Manual: **Owner's Manual P/N 6AB1WNM-2-20
(INSTALLATION MANUAL, MAINTENANCE MANUAL AND
ILLUSTRATED PARTS BREAKDOWN)**

TR-2024-004: 10 April 2024

2 - 7 - 5 TOUCHSCREEN RETROMODIFICATION INSTRUCTIONS

Figure 2-5 Retromod for Touch Screen Installation (Sheet 1 of 2)

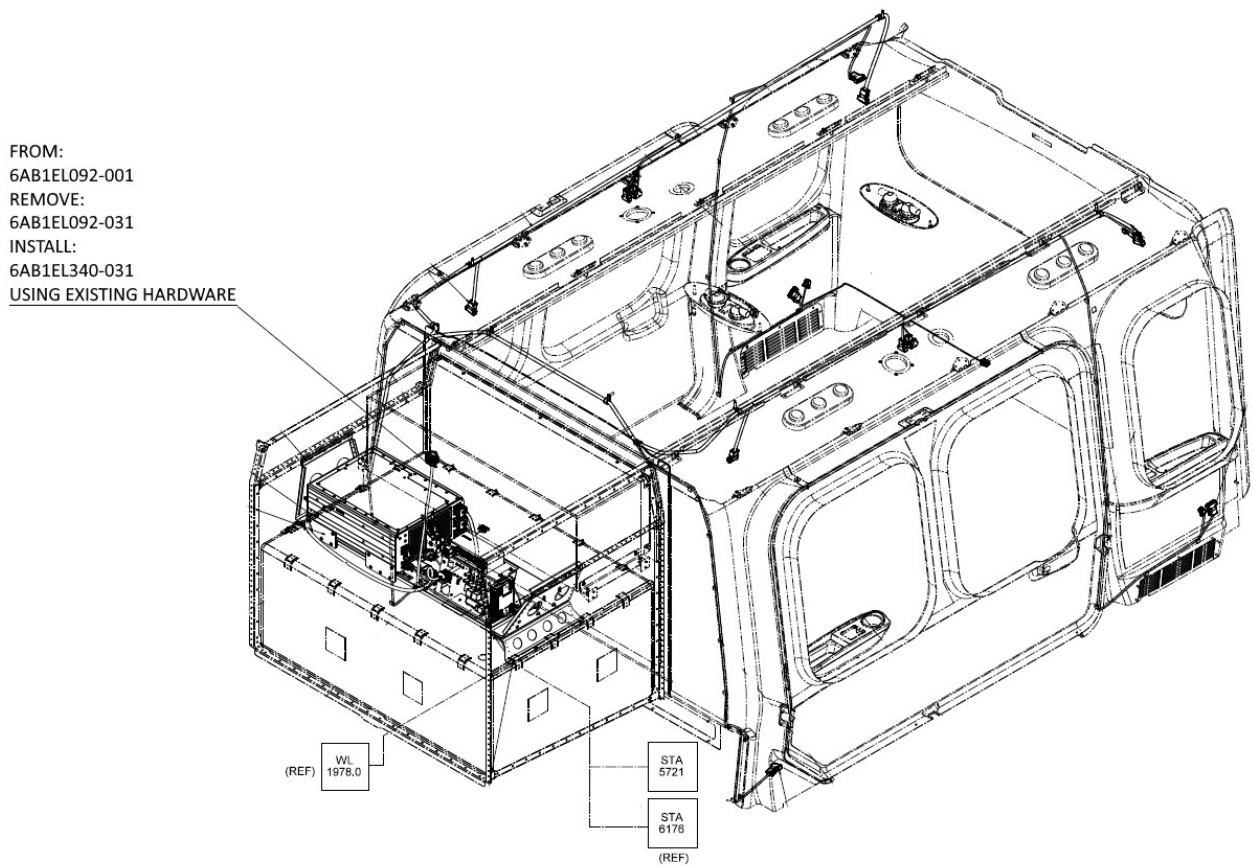
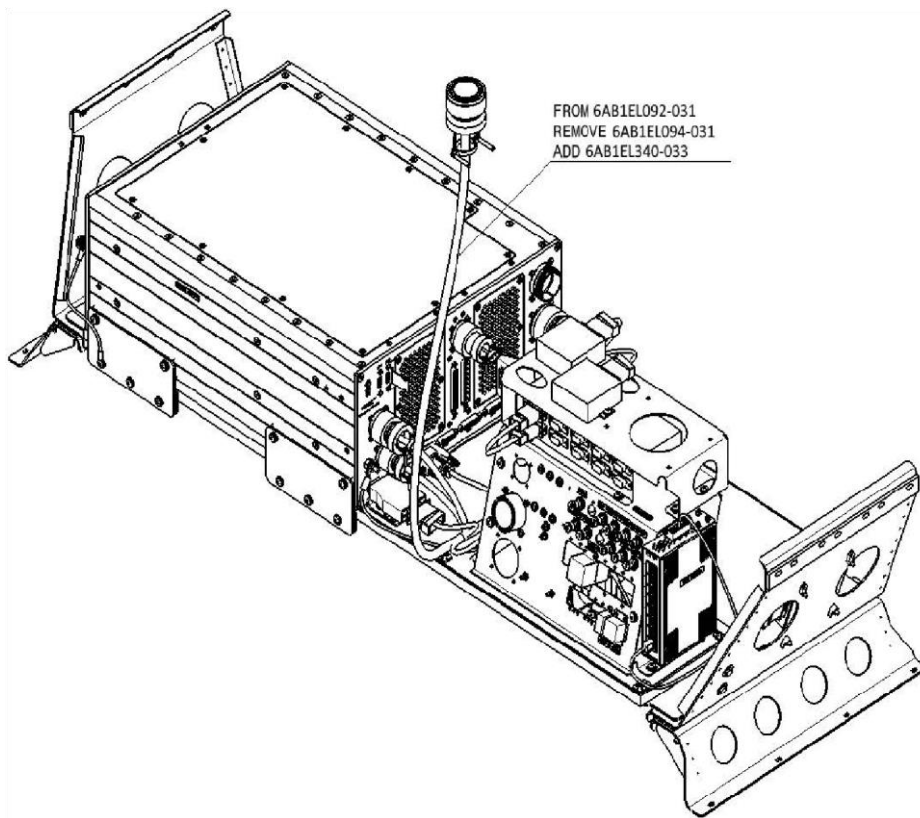
3. Gain access to the Equipment Rack Assy.
4. Making reference to the applicable Wiring Diagram [Figure 5-3](#), disconnect P1 PWR SPLY connector from VGA splitter DAPS350 and rework wiring in order to power touch screen with 28 Vdc current, as follows:

- a. Making reference to the former wiring diagrams [Figure 5-1](#), on connector P1 PWR SPLY:
 - i. Disconnect cable T3A20 from pin 1;
 - ii. Disconnect cable RZ14A22 from pin 4;

- iii. Disconnect cable RZ16A22 from pin 6;
 - a. Making reference to the updated wiring diagrams [Figure 5-3](#) on connector P1 PWR SPLY:
 - i. Splice together wires T3A20, RZ14A22, RZ16A22 and a wire AWG #20 unmarked.

- ii. Crimp a Pin P/N M39029/63-368 on AWG #20 unmarked cable;
 - iii. Connect AWG #20 unmarked cable to Pin 1;
 - iv. Leave Pin 4 and Pin 6 of P1 PWR SPLY unconnected.

5. Connect P1 PWR SPLY connector to VGA splitter DAPS350.
6. Remark Cable Assy P/N 6AB1EL094-031 with new P/N 6AB1EL340-033 using C/A Identification 6NV-EMI-001-002.

7. Remark Rack Assembly P/N 6AB1EL092-031 with new P/N 6AB1EL340-031.

Figure 5-1 Rack wiring diagram (Sheet 1 of 2).

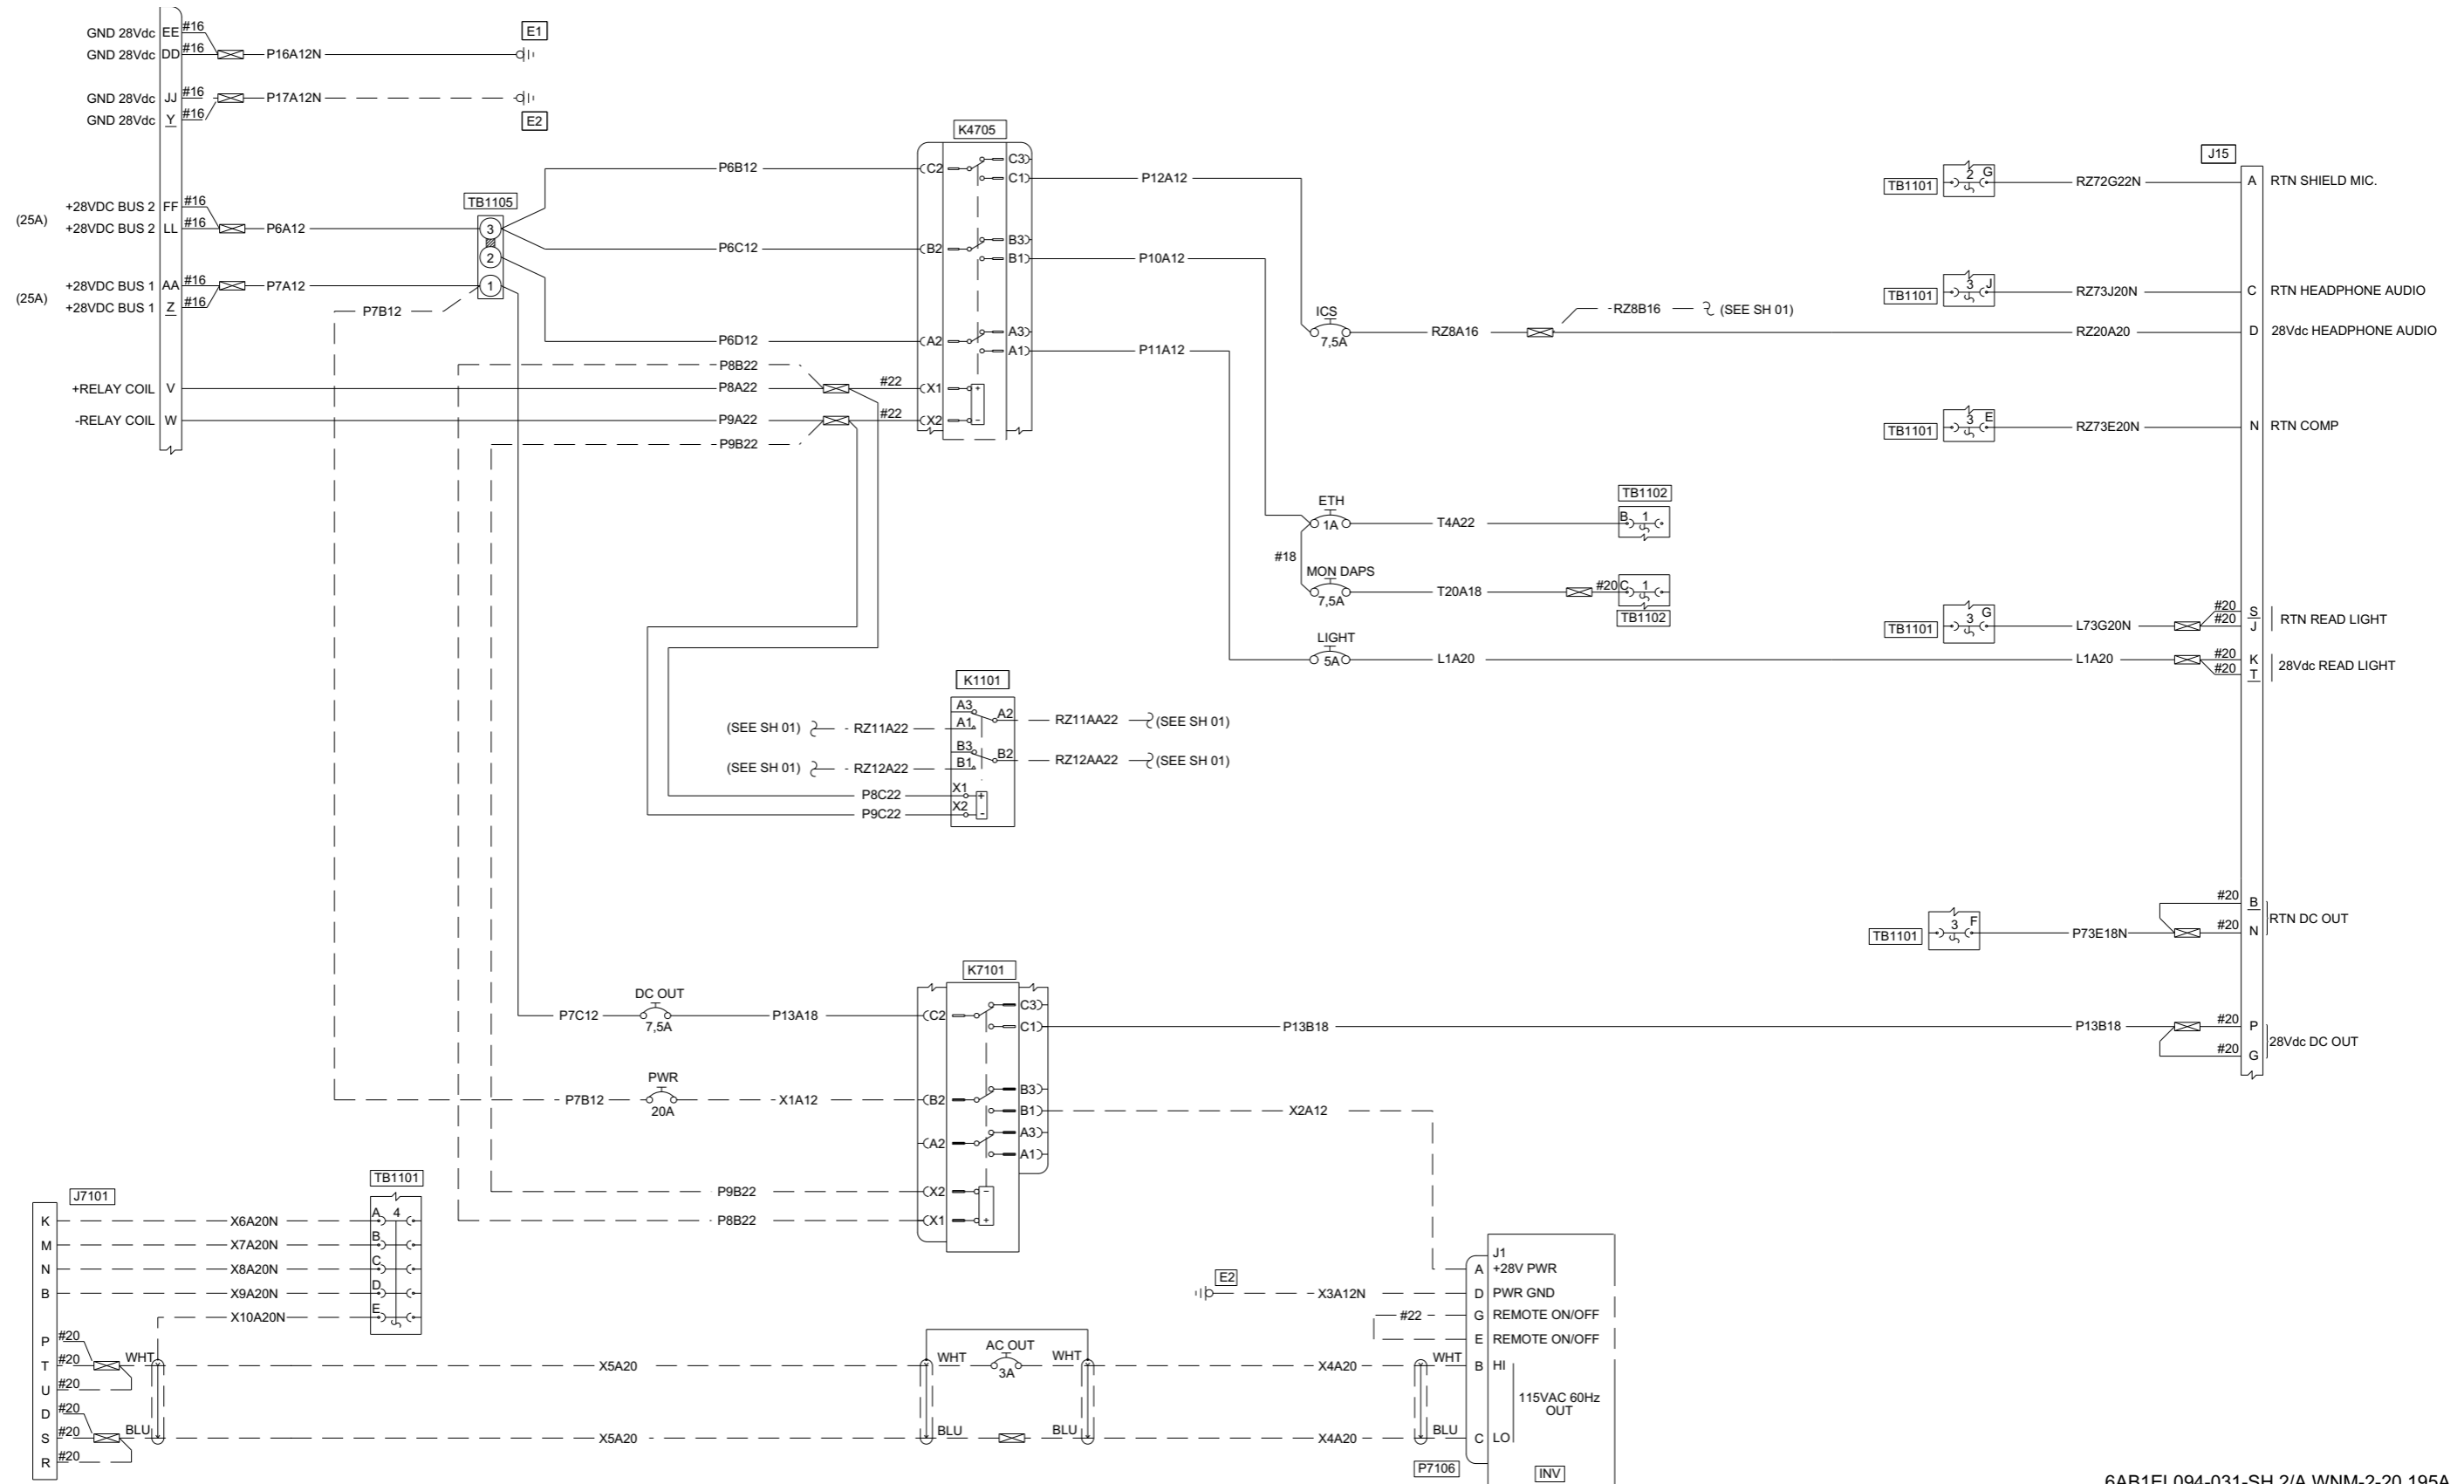
NOTE: This figure is **NOT** applicable when Retromod (31372) P/N 6AB1EL340-001 is installed. Refer to [Figure 5-3](#) of this Appendix.

Figure 6-4 Touch screen Retromod (Sheet 1 of 2)

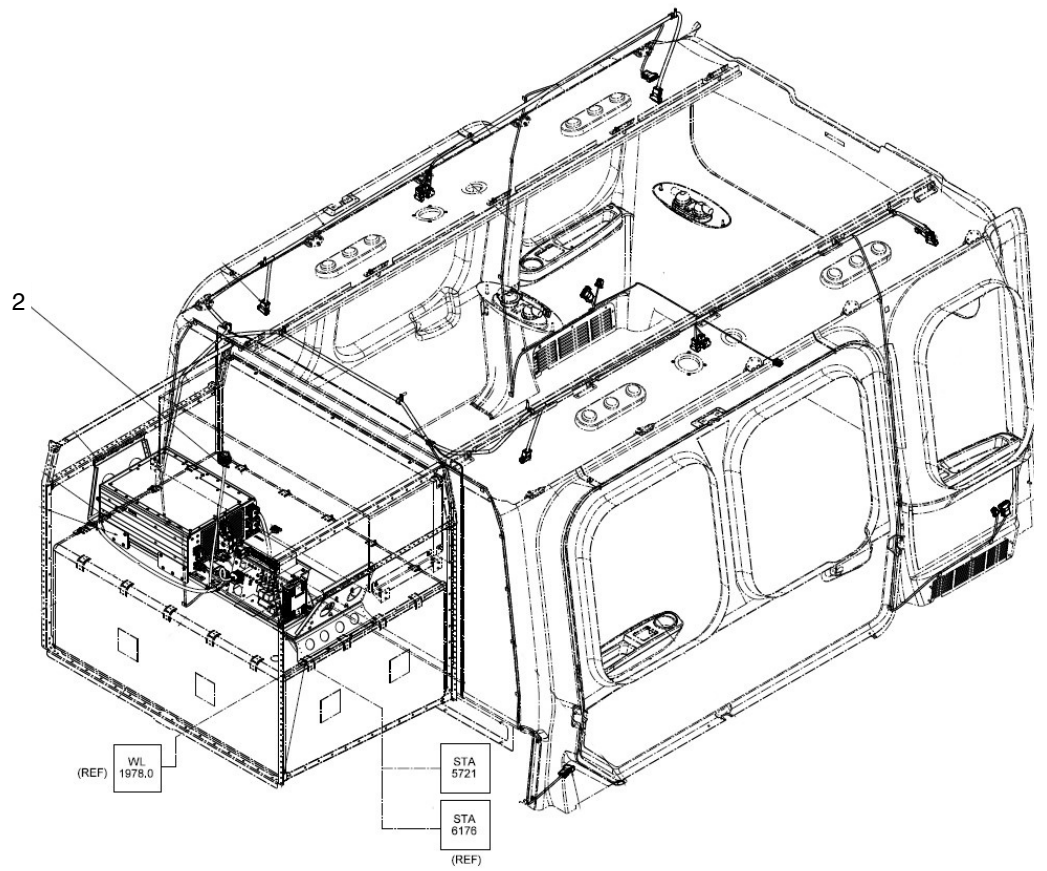
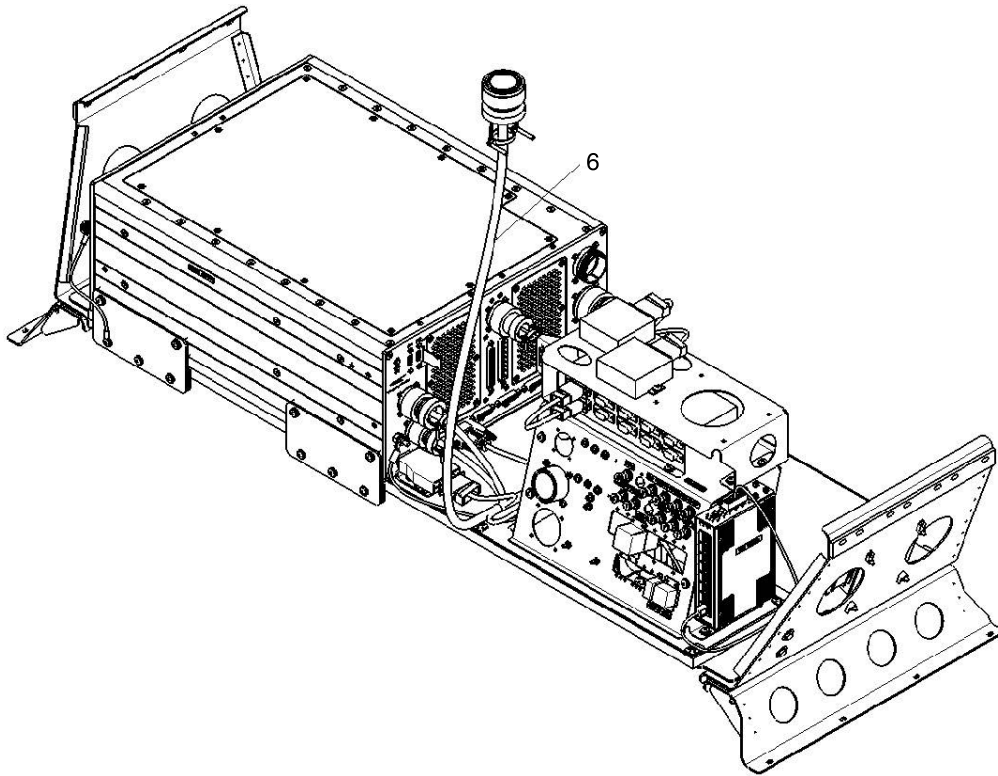
NOTE 5: The Touch screen Retromod (31372) shall be installed only when touchscreen P/N 6IFCP001-126 and P/N 6IFCP001-127 and P/N 6IFCP001-128 and 6IFCP001-129 are replaced with touchscreen P/N 6IFCP002-126/-127/-128/-129.
